INFORMATION PAPER

FACILITIES IN SPECIAL SCHOOLS FOR PHYSICALLY HANDICAPPED CHILDREN

Initial Views of the Education Department on the Suggestions of the Sub-committee and school staff

(A) Physiotherapy Room of Hong Kong Christian Service Pui 01 School

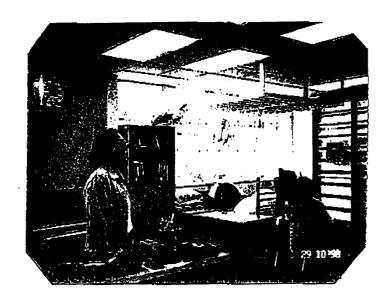
7. Physiotherapy Room

- Insufficient physiotherapy furniture and equipment and the School resorted to recycle discarded bicycle and gymnastic bicycle; and
- (b) no ceiling hooks.
- (1) The standard furniture and equipment list for the physiotherapy room includes 3 bicycles and 3 tricycles. Under the new grant for furniture and equipment, the School was allocated \$528,000 in the 1998-99 financial year. However, the School has only spent \$94,000 up to 31.10. 1998. The School should acquire such items through the new grant.
- (2) The ceiling rack of the room provides strong support, from which physiotherapy couipment can be hooked (see picture attached).

(B) Activity of Daily Living Room cum Occupational Therapy Room of Margaret Trench Red Cross School

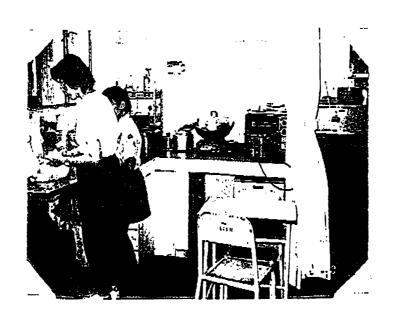
11.	Activity of Daily Living Room cum Occupational Therapy Room The cooking bench is inaccessible by wheelchair- bound students.		The school can remove the furniture and other stuff in the way (see picture attached).
